## Response to Council Letter regarding development at St Lucy's School, Wahroonga (DA0583/17, dated 17 April 2018)

This letter has been prepared in response to the traffic and parking related comments raised by Ku-ring-gai Council (Section 6 and 7 of the letter dated 17 April 2018) regarding the proposed development at St Lucy's School in Wahroonga.

Figure 1: Existing Traffic Flows (survey date: 10/05/2018)

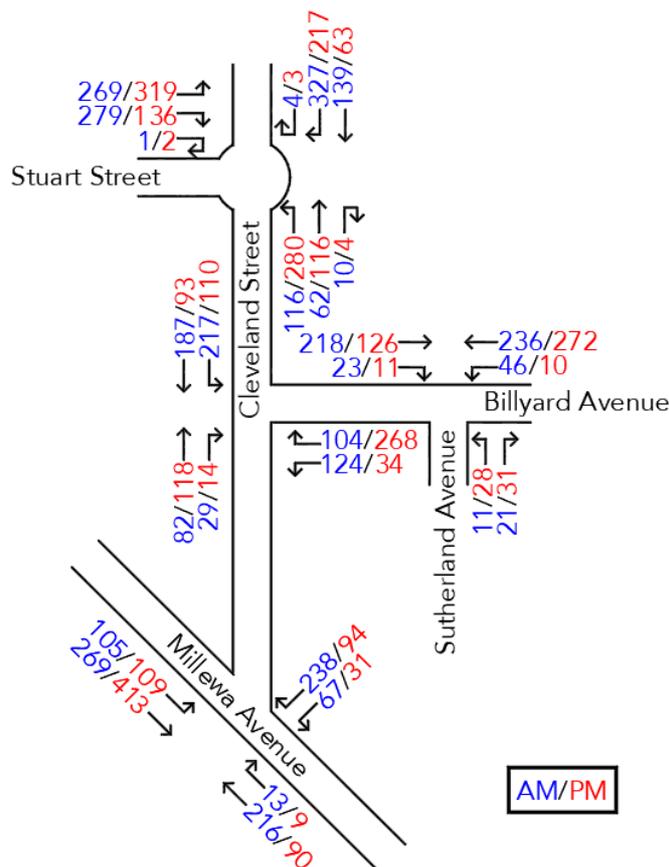
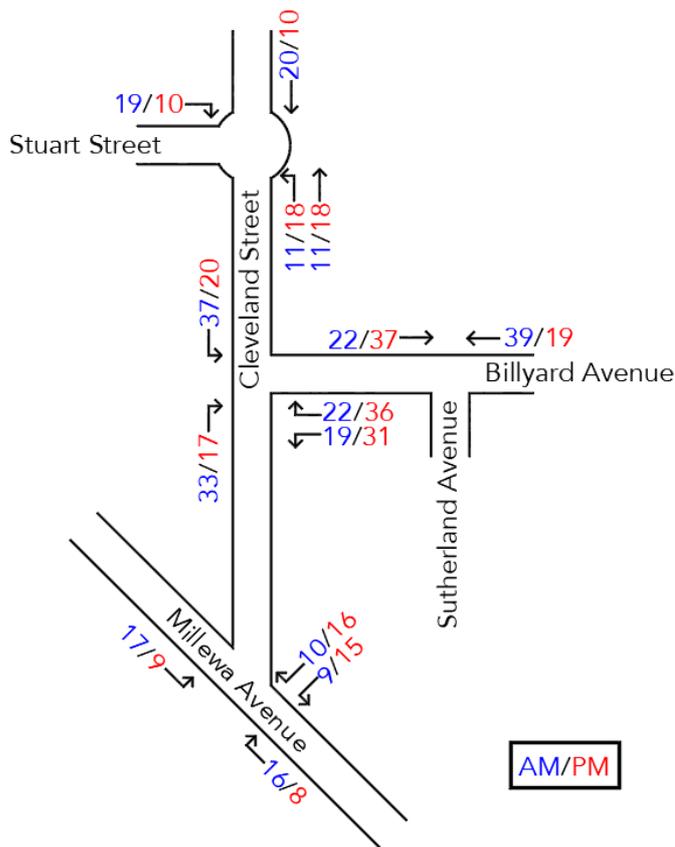
Section 7b: *As part of the traffic assessment, traffic counts are to be undertaken for the weekday AM and PM period for at least 3 days (Tuesday to Thursday) and carried out during school days to determine the peak traffic volumes. Traffic counts to be provided to analyse the impacts through the Cleveland Street/Stuart Street intersection due to the increased movements from the site, based on peak vehicle trip generation during the AM and PM peak. The dates of the counts are to be clearly stated in the report. Both pre and post development SIDRA analyses are to be included.*

Additional traffic surveys have been undertaken over 3 days. As stated in the previous section, revised SIDRA analysis for both the pre and post-development scenario has been undertaken incorporating the revised survey traffic volumes. The peak hour flows are presented in Figure 1 and Figure 2. A summary of the SIDRA modelling for the existing scenario and the development scenario is presented in Table 4.

As indicated by the SIDRA modelling, the proposed development is expected to have minimal impact upon the surrounding road network. All surveyed intersections are operating at a Level of Service A for both the pre- and post-development scenarios. Average delays for all intersections are minor and there is ample spare capacity in all four intersections. The busiest intersection, Stuart Street / Cleveland Street, has more than 50% spare capacity in the worse scenario (AM post-development).

Figure 4: Indicative construction vehicle route (Access in blue, egress in red)

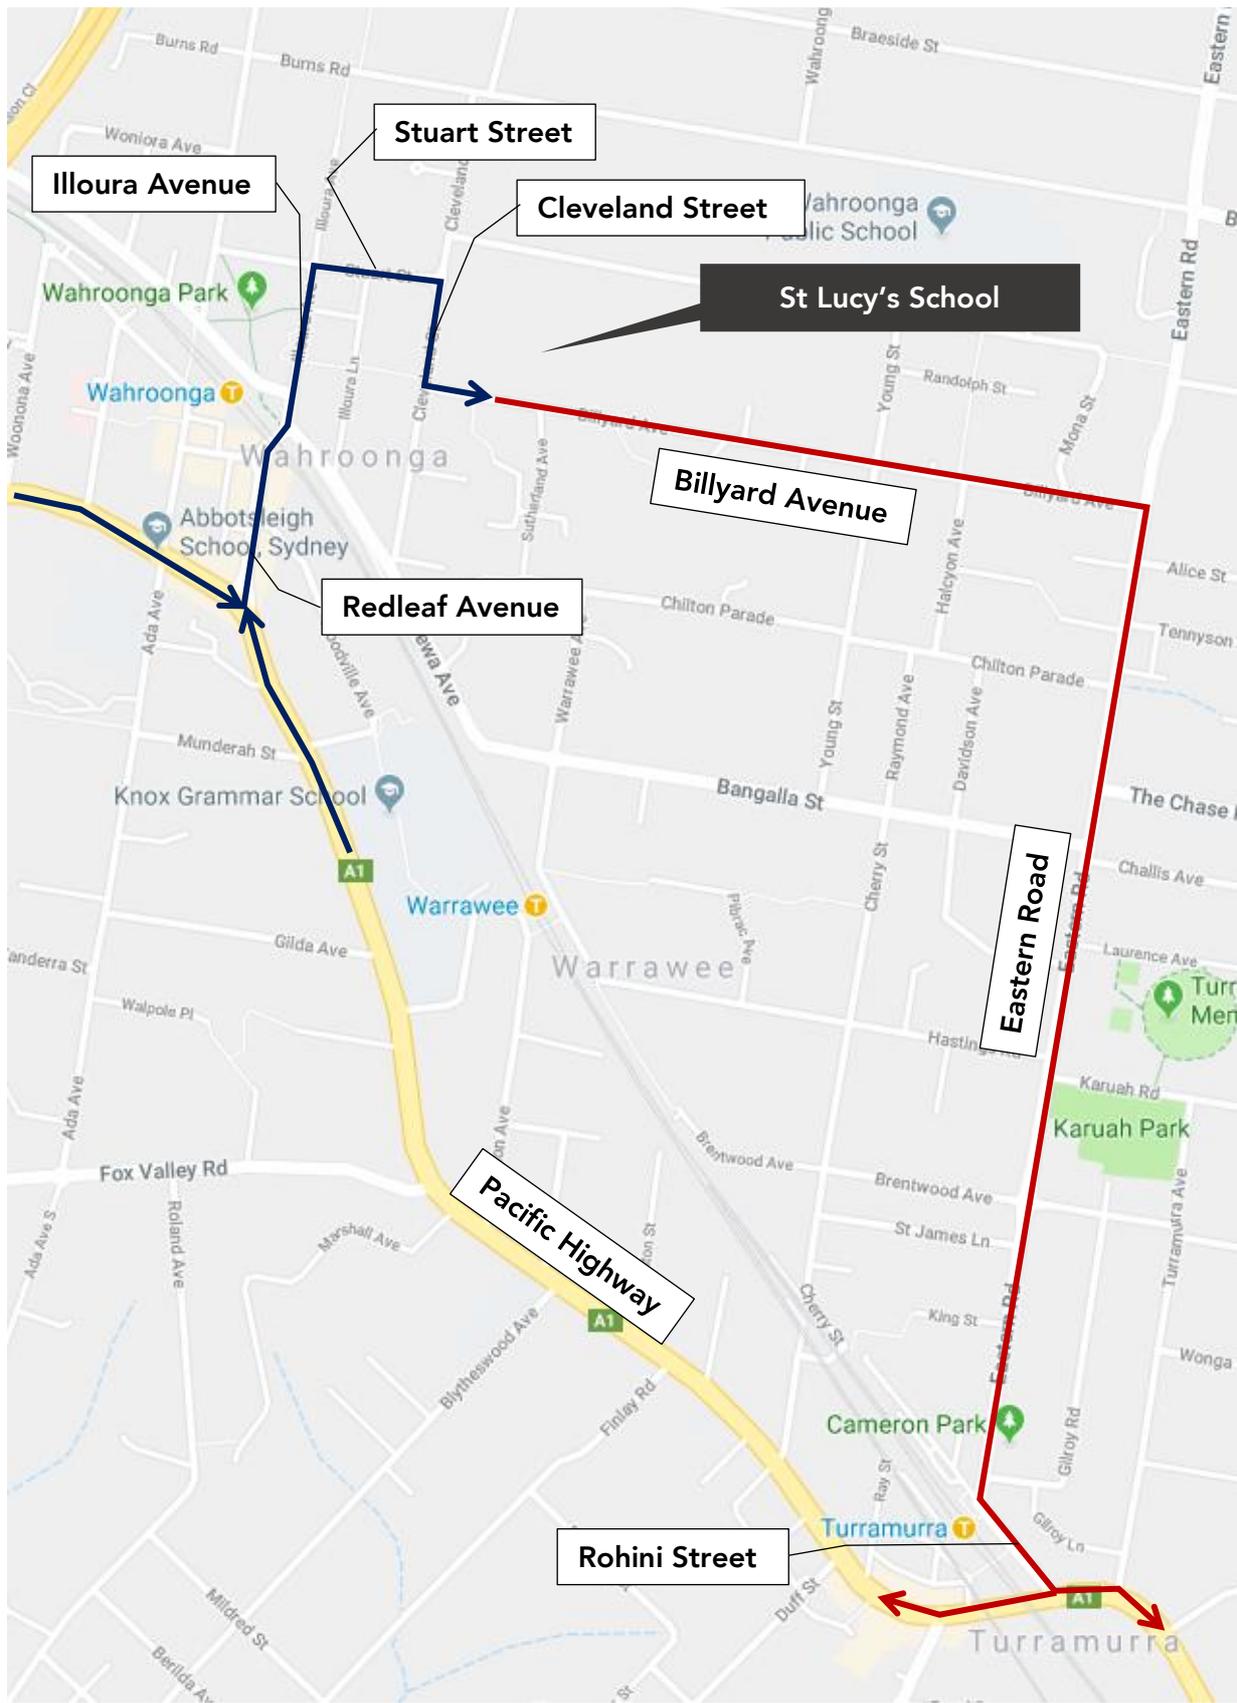
*Section 7c: An indicative construction traffic management plan is to be submitted (required under Council’s DA Guide). Plan to show the largest vehicle to be used entering and exiting the site for the demolition, excavation and construction stages, stockpiles and all necessary tree protection fencing. Consultation with the project arborist is recommended.*

An indicative construction traffic management plan has been prepared and is provided as an attachment to this letter ([Attachment 1](#)). The report addresses the details outlined in Council’s DA guide including:

- Commitments for minimising disruption to and maintaining the safety of residents, pedestrians and road users
- Construction vehicle routes for a 19m articulated vehicle for approach and departure to and from the site
- A site plan showing the proposed entry and exit points with swept paths of a 11m HRV showing access and egress via the provided driveway
- Details of construction employee parking and recommendations for parking restrictions if through traffic is likely to be reduced to one lane

An indicative construction vehicle route is outlined in Figure 4; the final route will be confirmed in the detailed CTMP in due course. This route shall be communicated to construction staff during the induction process. As a general requirement however, all drivers and associated companies are responsible for adhering to the road rules and regulations.

**Attachment 2 – Car Park Diagram**

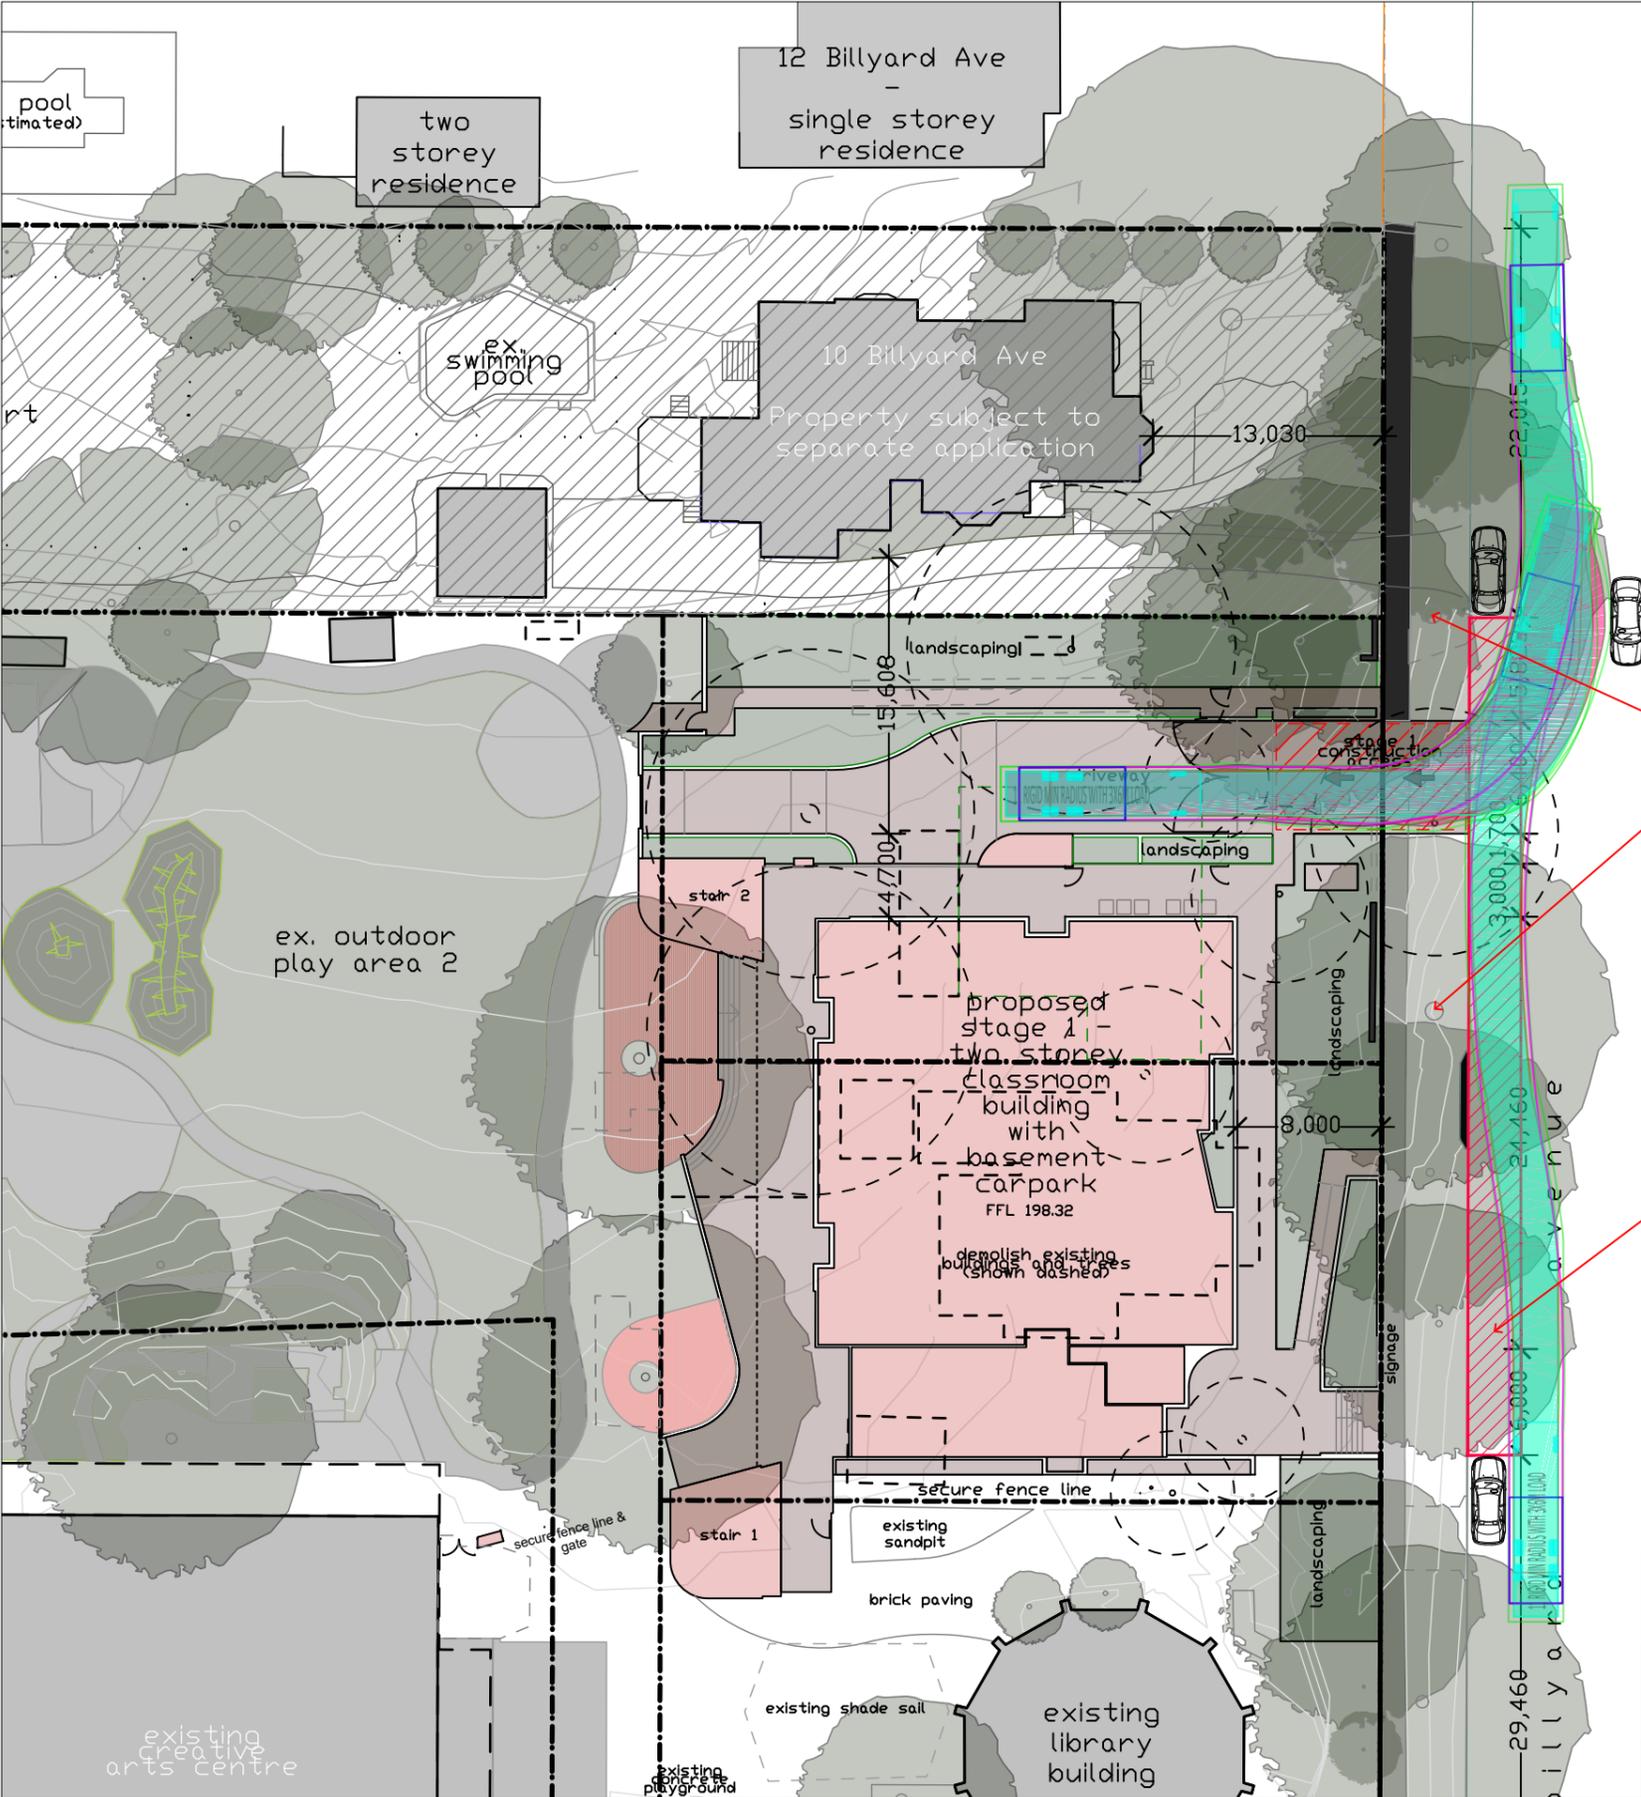
*Section 7f: It is proposed that private vehicles will enter the basement carpark to perform pick-up and drop-off. It is understood that children will be dropped-off/picked-up with an estimated 5 vehicles queued. Clarification is sought as to whether there would be any further queuing and significant delays within the basement carpark.*

A revisit of the car park plans has identified that there will be enough space for 6 vehicles to queue for drop-off/pick-up, rather than 5 as stated in the original TIA (See [Attachment 2](#)). Under the same assumptions regarding the drop-off/pick-up window and dwell times as established in the original TIA, a Poisson Queuing Analysis indicates that the 95<sup>th</sup> percentile queue will be 1 vehicle for the basement car park drop-off and 8 vehicles for the basement car park pick-up (refer to Table 2). It is estimated that the car park can accommodate up to 17 additional vehicles in the queue (not including the 6 vehicles undertaking drop-off/pick-up), before reaching the external road network. Hence, there is expected to be sufficient

room for further queuing within the site extents without impacting the external traffic or causing undue delay.
